USB3.0 Hub Controller

(Ver 5.0)

This document describes the notification of μPD720210, USB 3.0 Hub controller.

PCN Tracking Number : SAG-B-14-0008

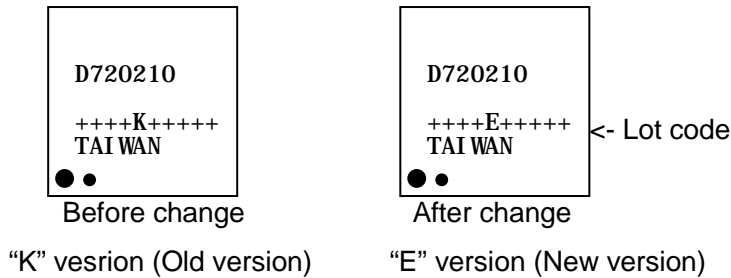
This item is the supplement for the following PCN (Product Change Notice).

This change enables the elimination of external SPI ROM. Systems using the current version with external SPI ROM are not affected by replacing the version with this change, because the functionality of these versions will be identical, in the case where they are used with the external SPI ROM.

Changing 5<sup>th</sup> character of lot code by each plant as below. (Before change : K, after change : E)

"E" version is backward compatible with "K" version.

Before		After		Notes
Version	ROM	Version	ROM	
“K”	Use	“E”	Use	Replace only the sample from "K" to "E". No need to make other changes. There is no impact on the current board design.
“K”	Use	“E”	Not use	Need to consider the pin strapping on the board. Need to set the pin strapping to become the same function between before change and after change.

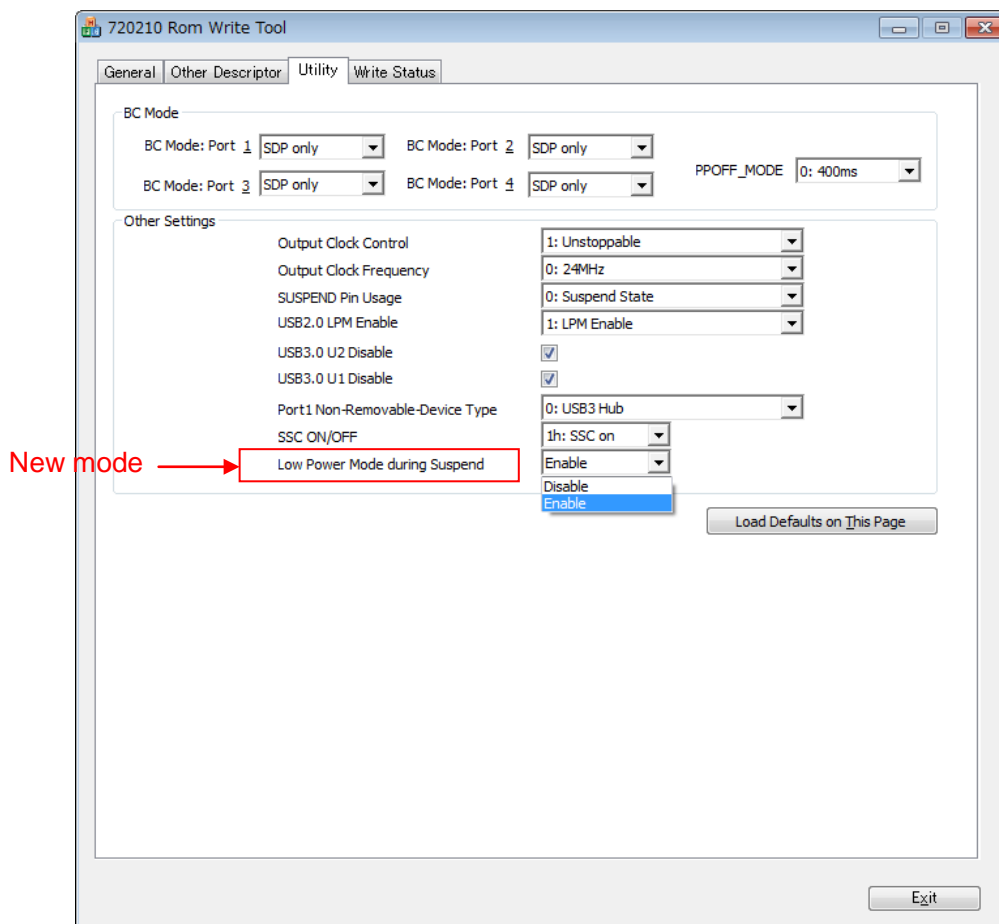
We disclose a new mode to reduce the power consumption of uPD720210 during Suspend (U3 State) where the uPD720210 is disabled from signaling a remote wakeup due to a connect or disconnect event. We named this new mode “Low Power Mode during Suspend”.

To enable it, use uPD720210 ROM Writing Tool Ver.1.3.0.0 or later to create FW Image data for the external ROM. The following figure shows the new dialog in the tool and the added list box to enable or disable the “Low Power Mode during Suspend”.
